CCK-2568-22

ADDENDUM # 4

CONSTRUCT/ IMPROVE GREEK HOUSING (DELTA GAMMA) Bid Package #2 – All Work Categories

UNIVERSITY OF KENTUCKY
 2555.0 Construct/Improve Greek Housing
 (Delta Gamma House)

H7 BUILDING SIGNAGE
0 2 4 FT

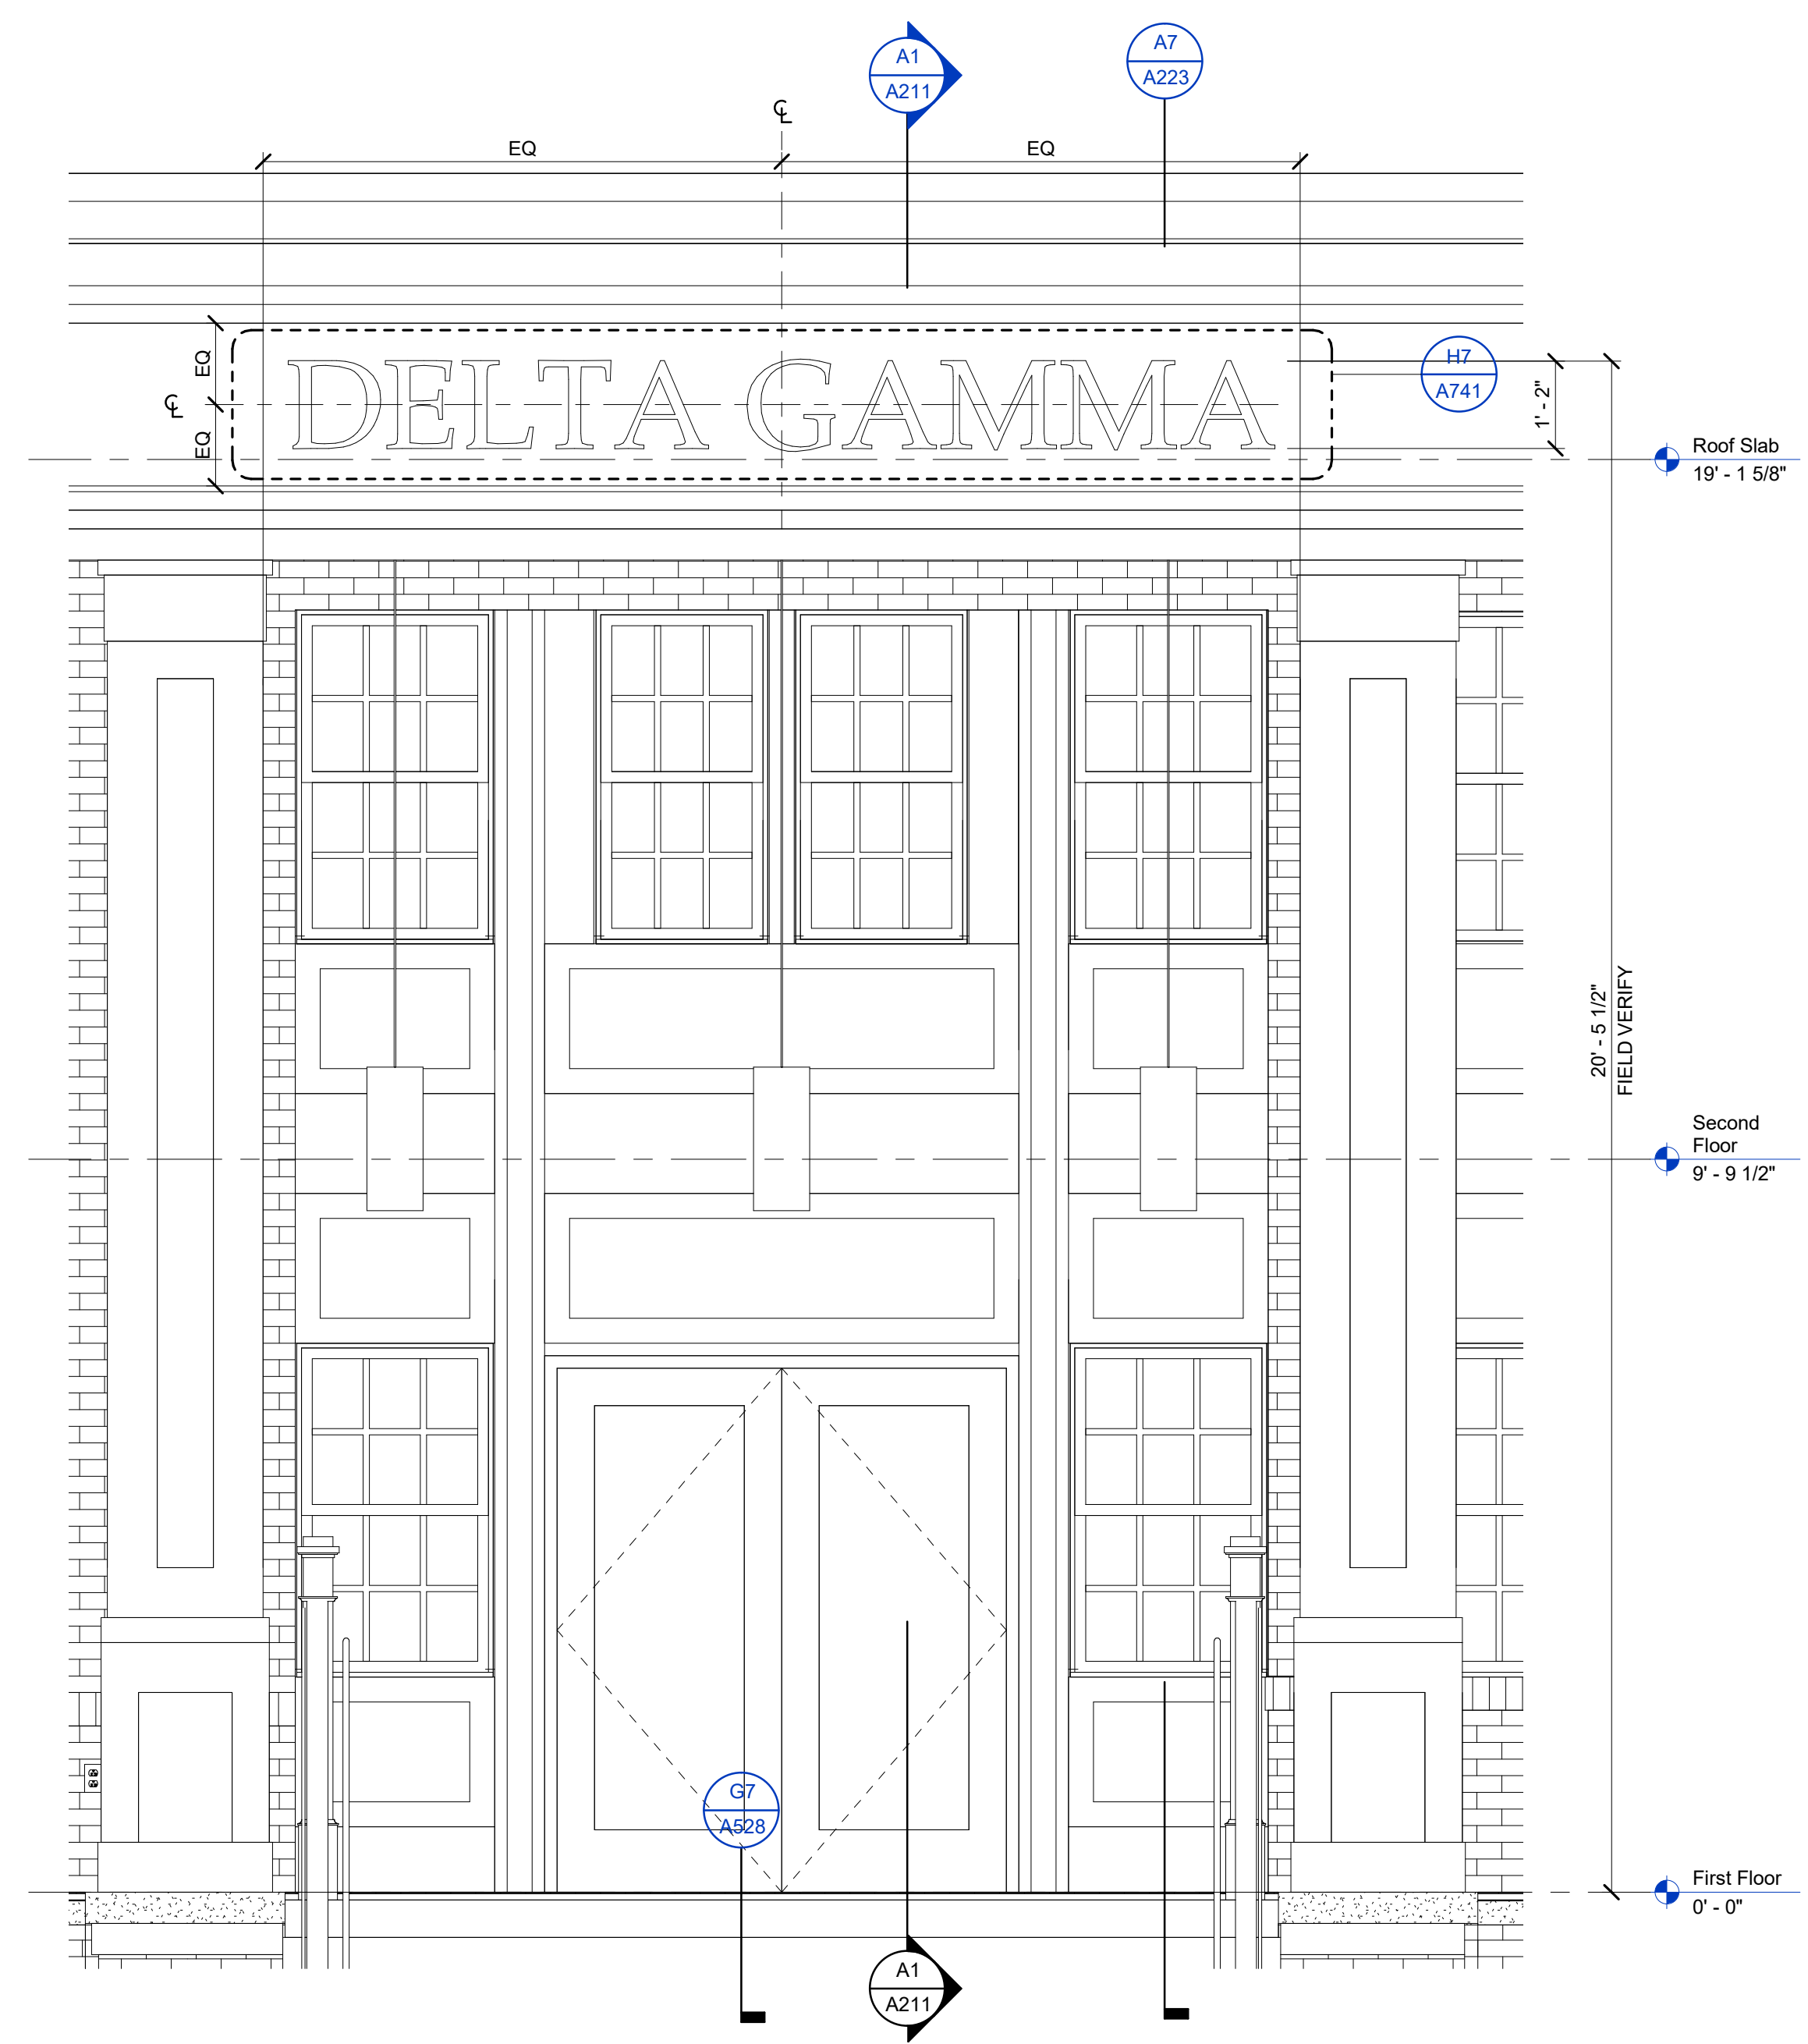
- Added new sheet for Exterior Building Signage (moved from Sheet A740).
